Olympus reference: QIL FY24-EMEA-01-FY23-OMTA-13

URGENT FIELD SAFETY NOTICE

Recall of Single Use Distal Cover MAJ-2315

Used with: EVIS EXERA III Duodenovideoscope TJF-Q190V, EVIS LUCERA Elite

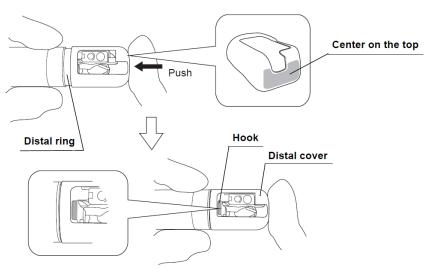
3 Gently hold the distal part of the bending section and the distal cover. Align the opening side of the distal cover with the lens side of the distal end of the endoscope.

4 Put your finger onto the center on the top of the distal cover and push the top of the distal cover straight onto the distal end of the endoscope until the hook of the distal ring is completely visible within the opening of the distal cover.

When attaching the distal cover, gently hold the bending section as close to the distal end as possible. Forcefully grasping other parts of the bending section can damage the mechanism of the bending section or deform its covering. It may also become impossible to straighten the bending section during an examination.
